● RIVER BEND STATION ENVIRONMENTAL REPORT

SUPPLEMENT 3

Acknowledgement of Receipt of
Supplement to Environmental Report-
Operating License Stage
River Bend Station

SUPPLEMENT 3 INSERTION INSTRUCTIONS RIVER BEND STATION
ENVIRONMENTAL REPORT - OPERATING LICENSE STAGE

FIGURE 3.4-3a
 ESTIMATED INITIAL SEDIMENT
 DEPOSITION LOCATIONS
 IN EMBAYMENT
 RIVER BEND STATION
 ENVIRONMENTAL REPORT-OLS

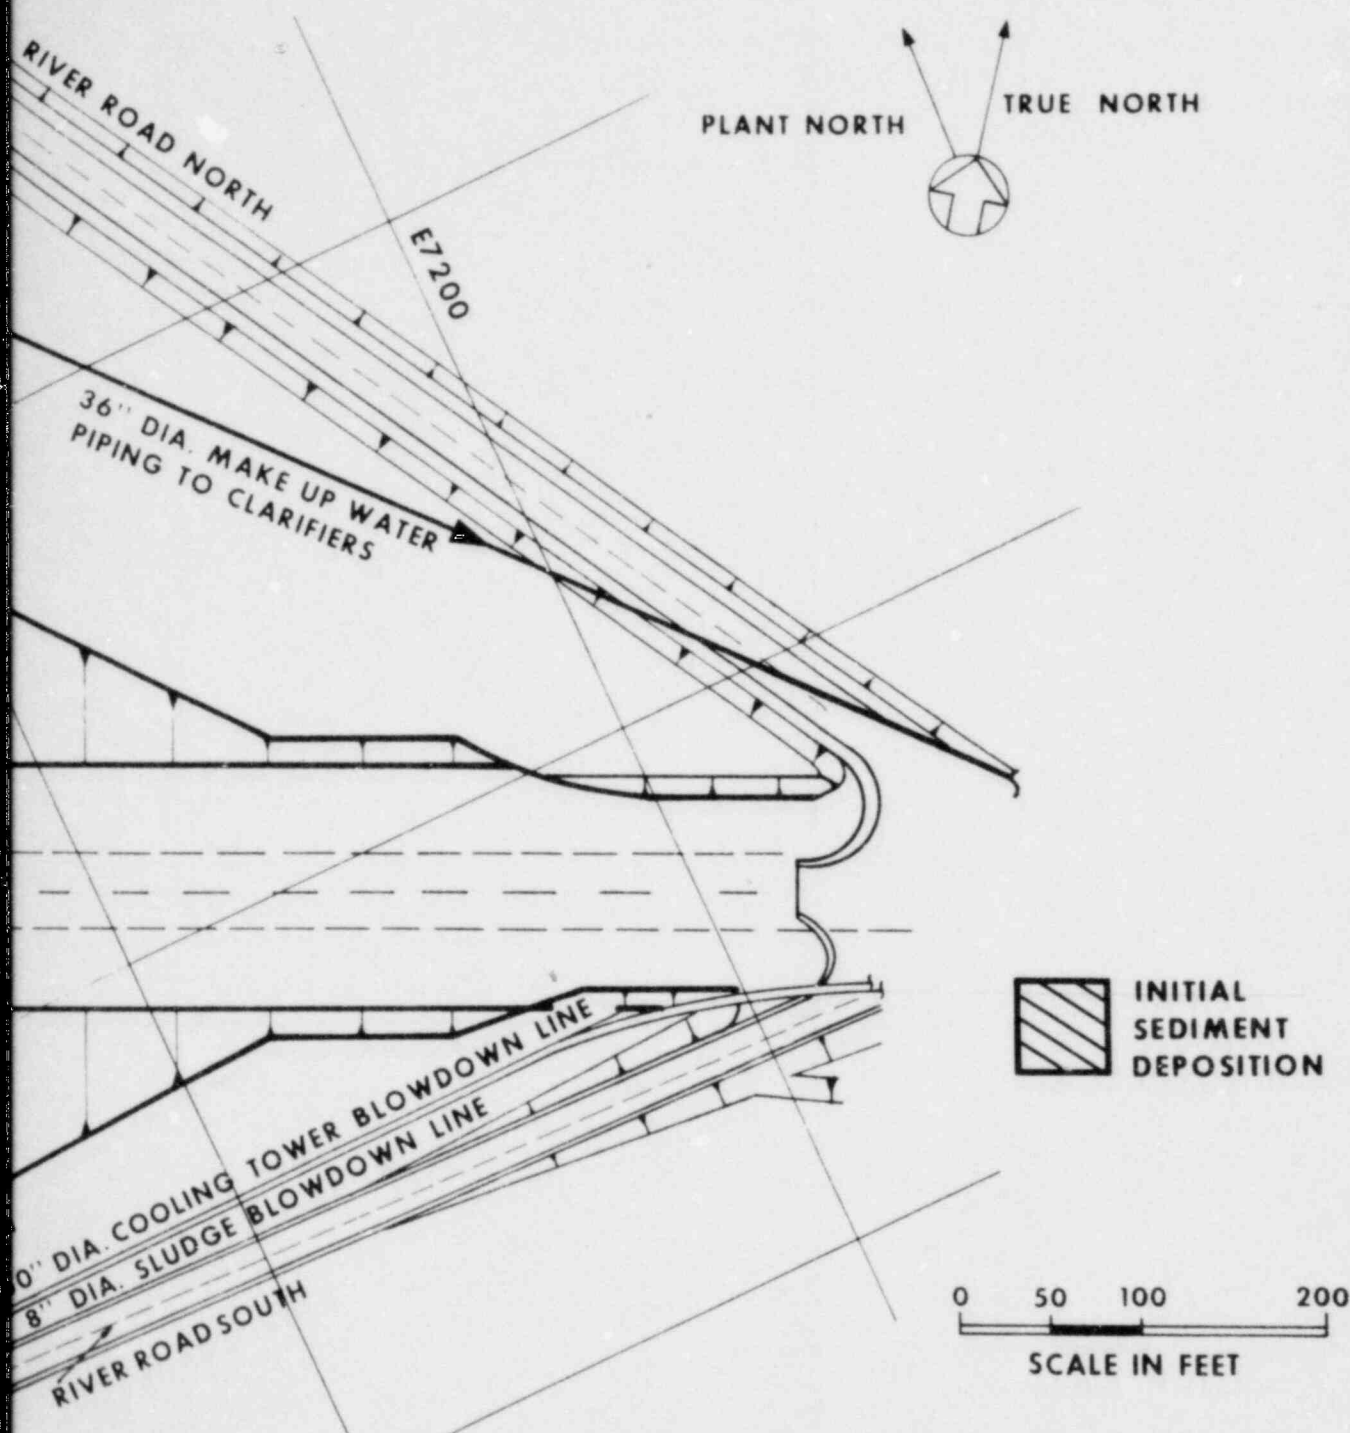
QUESTION E240.29 (FSAR 2.4.11.5/ER-OLS 3.4)

It is stated that sandbars form gradually along the passageway upstream of the makeup water intake structure embayment. Provide drawings showing the configuration of the embayment and bargeslip, indicating location and aerial extent of sandbar growth.

The response to this request is provided in revised Section 3.4.1.2 and Figure 3.4-3a. See also response to Question E240.28.
